Site Boring Work at Westpark Elementary School
SOUTHERN KERN UNIFIED SCHOOL DISTRICT
F&M Project No. 3045
Bid Clarification No. 1; Page 1 of 1

BID CLARIFICATION NO. 1
April 18, 2025

ADDITION OF PRE-K AND T-K CLASSROOMS AT
WESTPARK ELEMENTARY SCHOOL
3600 IMPERIAL AVENUE
ROSAMOND, CA 93580

SKUSD- BORING SCOPE AT WESTPARK ELEMENTARY SCHOOL

E1.01

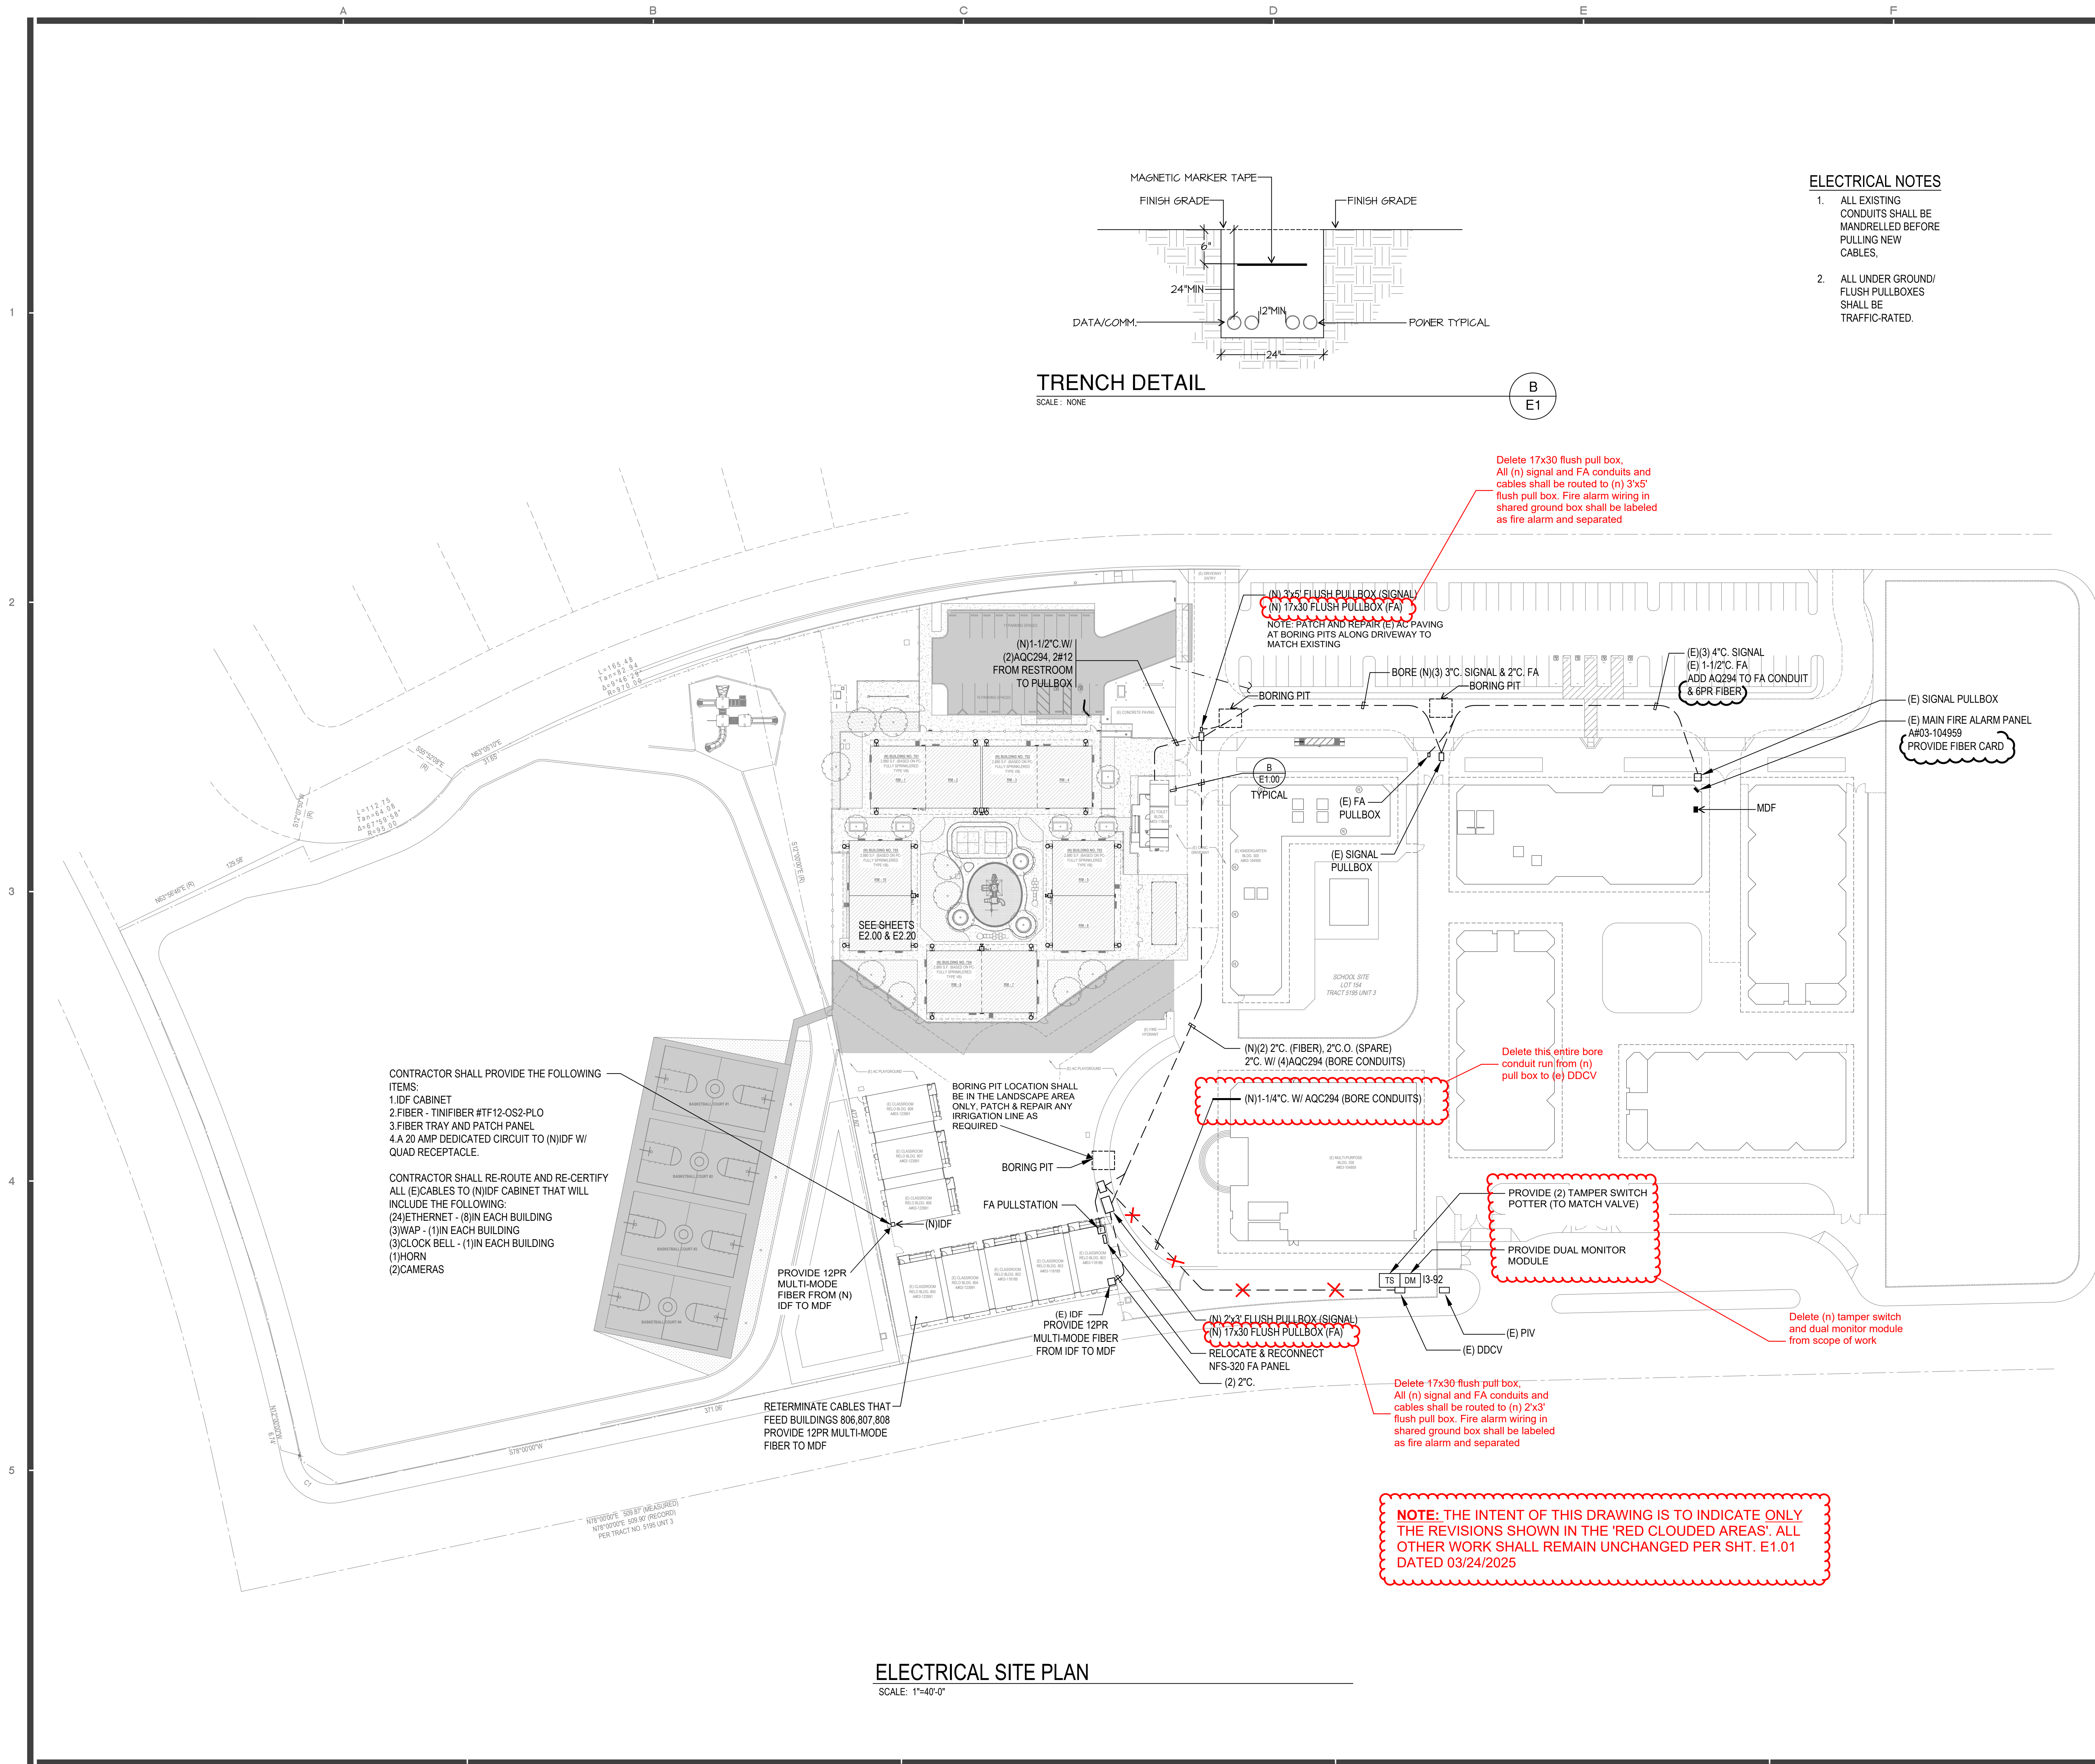
1. Sheet E1.01, **Revise** 'Overall Electrical Site Plan', Bid Clarification No.1, with revision clouds as attached hereto.
2. Sheet E0.20, **Add** 'Boring Project – Fire Alarm Riser Diagram & Schedules', Bid Clarification No.1, with revision clouds as attached hereto.

1. E1.01 states "Relocate and Reconnect NFS-920 FA Panel". Where is the (E) NFS-320 FA panel currently located? **IN NORTHEAST MOST RELO.**

2. E1.01 With the relocation of the (E) NFS-320 FA Panel from its (E) location to the south relo classrooms, will it be required to test the entire FA system or just the classrooms affected by the panel relocation?

6. E1.01 Relo 803 & 806 call for new 12pr multi mode fiber to the (E) and new IDF cabinets in the respective rooms, yet the call out for fiber cable from the MDF shows only 1ea. ~~6~~ pair fiber.

1) SHT. E1.01 To confirm the indicated 2'x3' & 3'x5' pull boxes will be traffic rated full concrete structure including bottom with ends and side conduit entries. The traffic rated metal covers will be bolt down type not a hinged & bolted cover. **YES**

2) SHT. E1.01 To confirm the indicated 17"x30" pull boxes will be traffic rated 12" top with a 12" extension section with open bottom. **ALL 17x30 PULL BOXES WILL BE DELETED, SEE BC#01, SHT E1.01**

3) SHT. E1.01 Per the discussion at the job walk the 1-1/4" conduit run with the AQC294 cable and boring from the Fire Alarm pull box near classroom 803 to the existing BackFlow and PIV at southern rear area of school are removed from scope of work because this item is already installed. **YES**

- 1) SHT. E1.01 Please confirm all 1-1/2", 2" & 3" underground conduit will be SCH 40. PVC.
- 2) SHT. E1.01 Please confirm all underground 90 degree elbows are Galvanized Rigid Steel Schedule 40 wrapped in 10 mill half lap vinyl tape.

JUST AFFECTED CLASSROOMS

Answer: **ALL NEW FIBER SHALL BE 12PR**

CONFIRMED

CONFIRMED

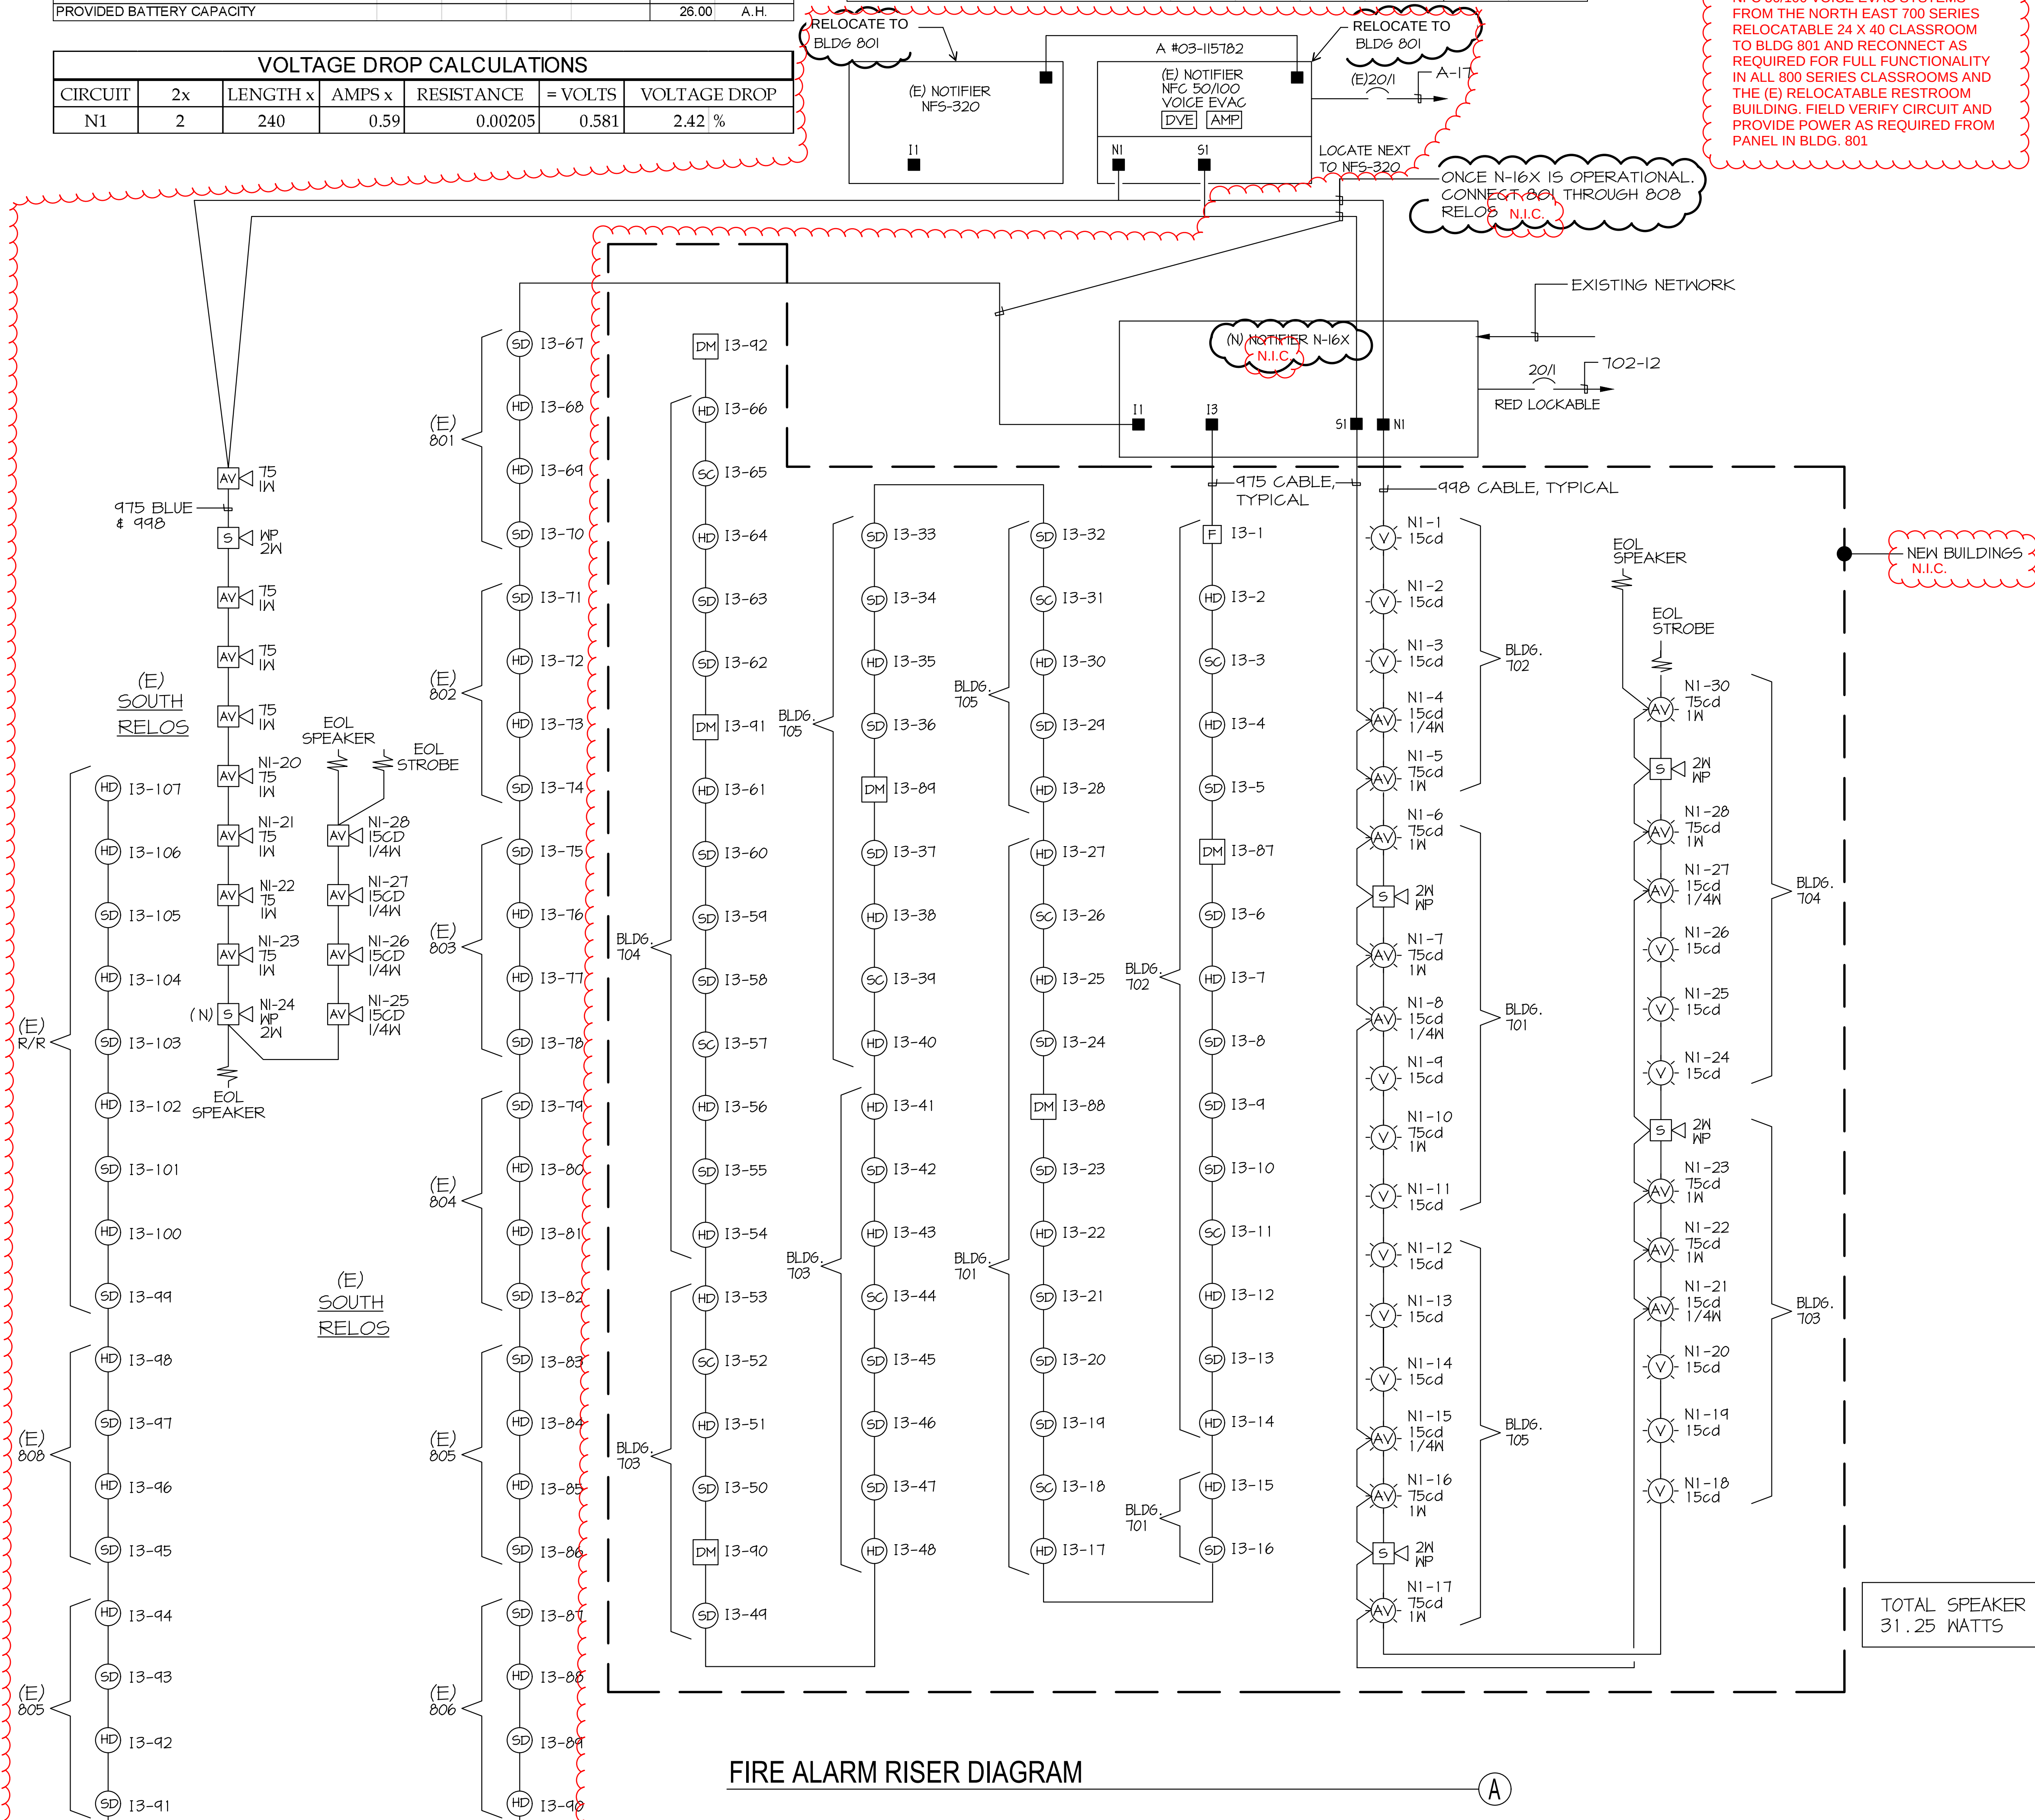
5. Between grid lines 2 & 3 and grid lines C & D the FA pathway from the (E) restroom building is shown going into the signal box not the FA box.

7. Provide Fire Alarm Riser Diagram for the 800 block classrooms and the existing restroom bldg (refer to BC #2 plan E0.02, battery calc as well as riser diagram)

Response: **See attached sheet E0.20, Bid Clarification no.1 dated 04/18/2025**

Answer: **See attached sheet E0.20, Bid Clarification no.1 dated 04/18/2025**
